STATE OF WASHINGTON
DEPARTMENT OF ECOLOGY

Pacific Wood Treating Corporation
Ground Water Evaluation - Phase I

SUBJECT: PWT GROUND WATER MONITORING PLAN, RIDGEFIELD, CLARK COUNTY

PACIFIC WOOD TREATING
SITE PLAN
Sweet, Edwards & Associates
P.O. Box 1000
Portland, OR 97208

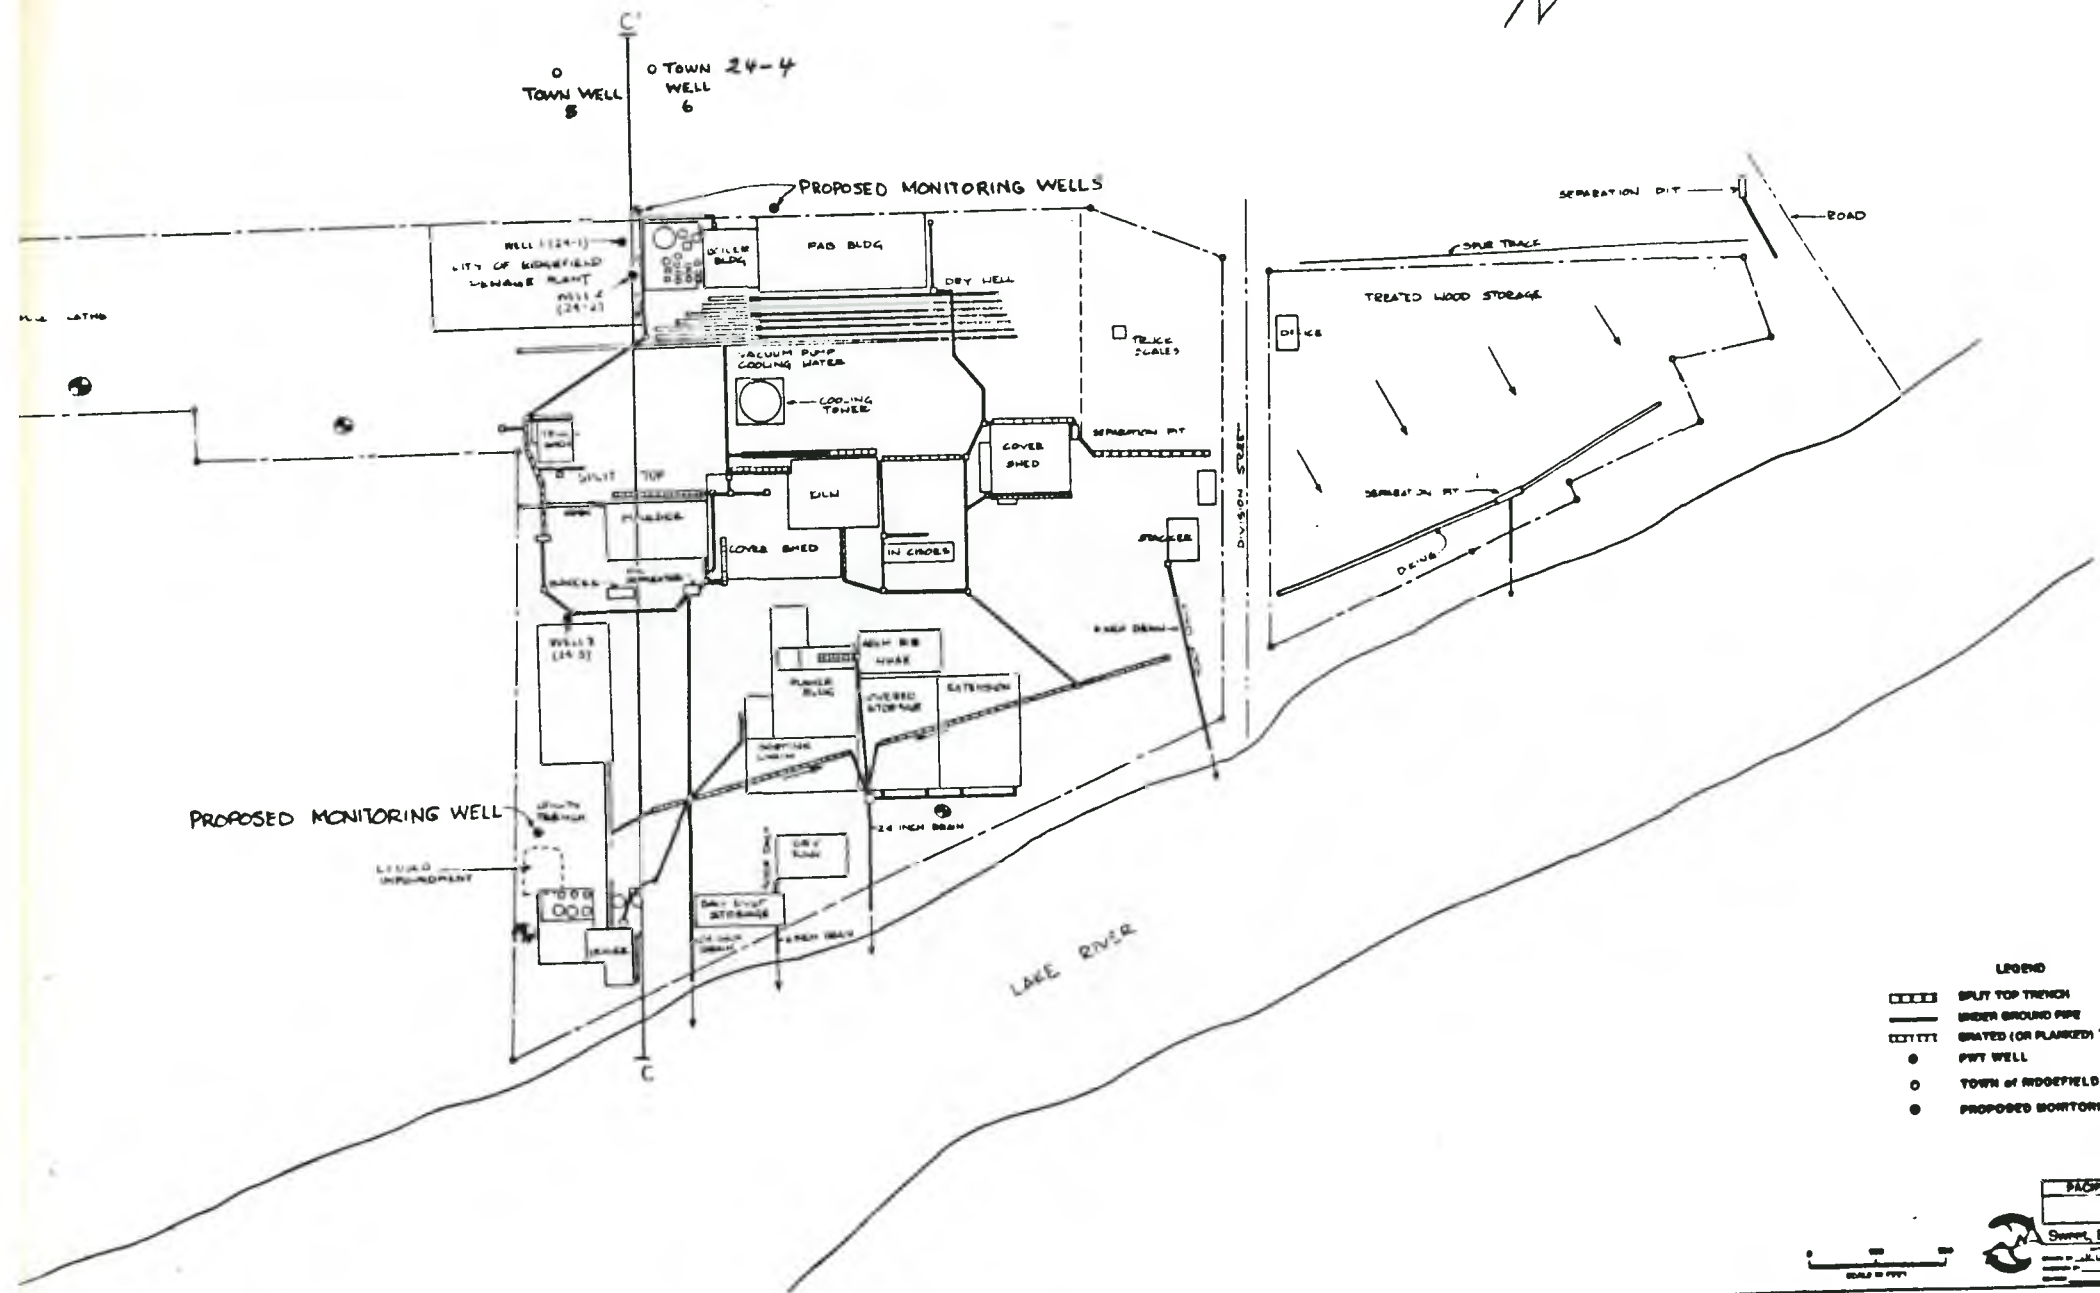
2. For water quality monitoring, we propose four wells in addition to your proposed three monitoring wells (see enclosed map). These monitoring wells are located in areas of past and present PWT waste disposal practices. We concur with your consultant that a full K001 pollutant screening is probably not necessary, and only indicator pollutants should be used such as pentachlorophenol, anthracene, chrysene, penanthrene, chrome, and arsenic. Your list of conventional water quality parameters should also include total hardness. Please propose the detailed monitoring program prior to the beginning of Phase II.

Regarding the monitoring plan, the proposed three new monitoring wells seem like a pretty minimal number, and with only one monitoring well on the downstream side, it seems like this could completely miss a significant pollutant plume. What do you think? Overall, the plan seems like a good start.
